SERVICE INFORMATION LETTER NO. 0184

Revision 3

1. SUBJECT: Collective Trim Adjustment Rod Assembly, P/N 28-16242
2. MODEL: F-28C, F-28C-2, F-28C-2R, F-28F, F-28F-R, 280C, 280F, and 280FX
3. EFFECTIVITY: All S/N; excluding F-28F S/N 833 and subsequent and 280FX S/N 2164 and subsequent (see compliance note pertaining to other serial numbers)
4. BACKGROUND:

Figure 3. Collective Trim Adjustment Rod Assembly

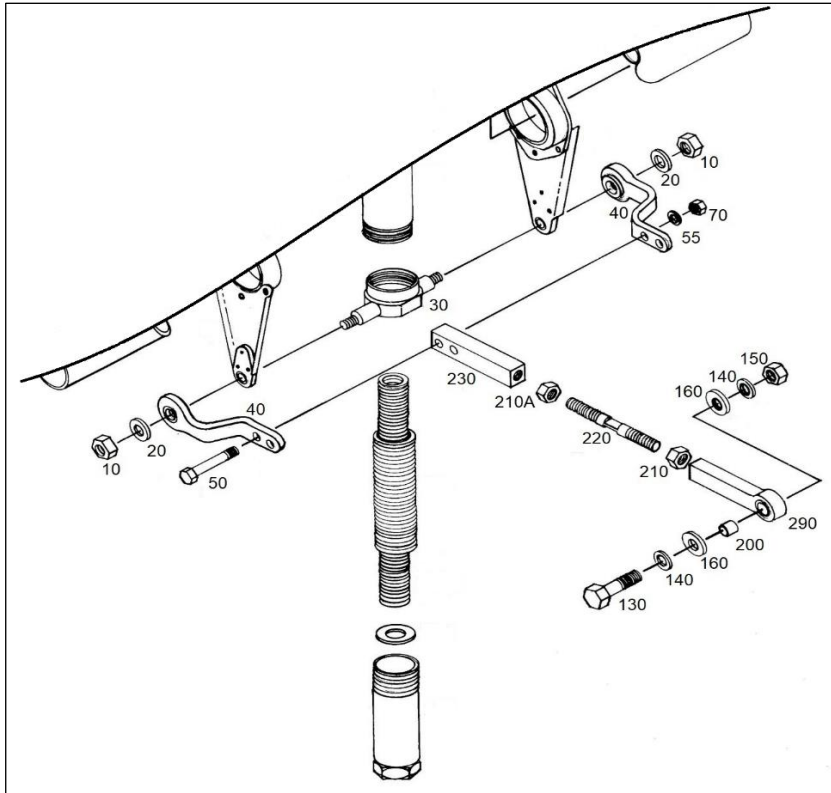
This SIL provides information regarding the installation of collective trim adjustment rod assembly P/N 28-16242-1 or collective trim adjustment rod assembly P/N 28-16242-7. Updates to this assembly allow greater adjustment of the collective trim capsule phasing which will simplify collective balance adjustment.

Revision 2 updates collective trim adjustment rod assembly P/N 28-16242-5 to P/N 28-16242-7 and kit P/N 28-16242-903 to P/N 28-16242-907.

- 6.5.1 Thread nuts (210 and 210A) on the tie rod (220). Note: Install appropriate left- or right-hand nut on the applicable left- or right-hand thread end of the tie rod.
- 6.5.2 Assemble links (230 and 290) and tie rod (220). Note: Link (290) is installed on left-hand thread end of the tie rod.
- 6.5.3 Install the tie rod assembly to the seat structure with bolt (130), washers (140, 160), spacer (200), and nut (150).
- 6.5.4 Install the brackets (40) to the pivot housing (30) with washers (20) and nuts (10) (torque 12-15 in-lb/1.4-1.7 Nm).
- 6.5.5 Attach the brackets (40) to the tie rod assembly with bolts (50), washers (55), and nuts (70) (torque 12-15 in-lb/1.4-1.7 Nm).

- 6.5.5.1 To align the link (230) and bracket (40) attachment holes, turn the tie rod left- and right-hand nuts (210 and 210A) in or out as required. (It may be helpful to use the length measured in step 6.4.1 to assist with a starting point for finishing the assembly.)
